**ZONING CHANGE REVIEW SHEET**CASE: C14-2022-0156DISTRICT: 1ADDRESS: 10711 Decker LaneZONING FROM: I-RRTO: CS-MUSITE AREA: 99.72 acres (4,242,803.20 sq. ft.)PROPERTY OWNER: Heart of Manor LPAGENT: Kimley-Horn (Ethan Harwell)CASE MANAGER: Jonathan Tomko (512-974-1057, [jonathan.tomko@austintexas.gov](mailto:jonathan.tomko@austintexas.gov))STAFF RECOMMEDATION: Staff recommends CS-MU zoningPLANNING COMMISSION or ZONING AND PLATTING COMMISSION ACTION /  
RECOMMENDATION:

**Project Name and Proposed Use:** 10711 DECKER LANE. C14-2022-0156. Project: Webb Tract Rezoning. 99.72 acres from I-RR to CS-MU. Proposal: Mixed-use commercial and residential development. Nov 9, 2022

**Date:** March 28, 2023  
**To:** Santiago Araque, P.E., Kimley-Horn and Associates. Inc.  
**CC:** Bryan Golden, Maria Cardenas, Austin Transportation Department  
**Reference:** Transportation Impact Analysis Final Memo  
Webb Tract - C14-2022-0156

Figure 2 Location of the Improvements

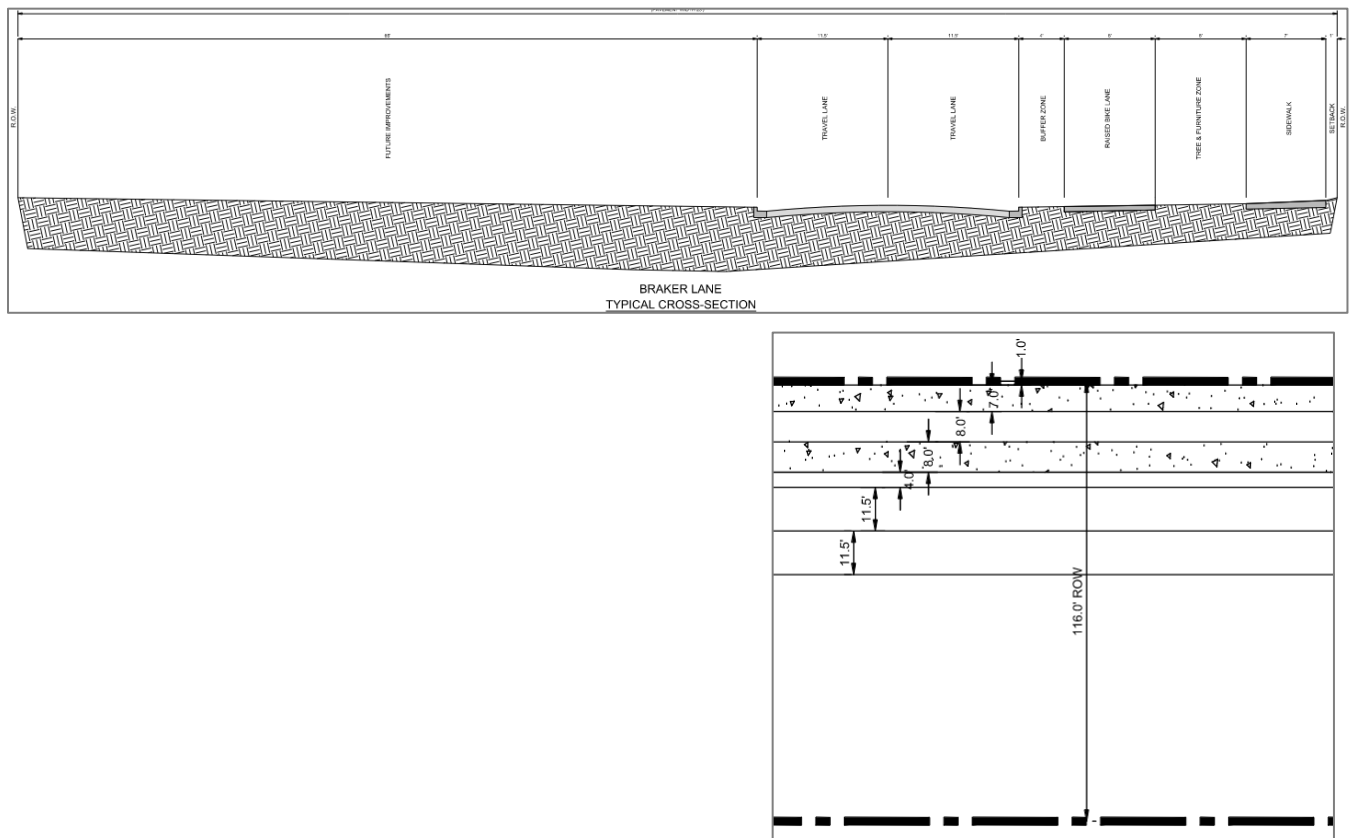
Name	Improvement	Cost	Developer's Share
Braker Lane Extension (See Exhibit A for the improvement extent)	Design and construct half of Braker Lane's cross-section per ASMP per COA standards within the property boundary	\$1,969,679	100%

1. The applicant shall dedicate 116 feet of right-of-way for Braker Lane extension as per Austin Strategic Mobility Plan (ASMP) prior to the approval of the first subdivision or site plan application, whichever occurs first.
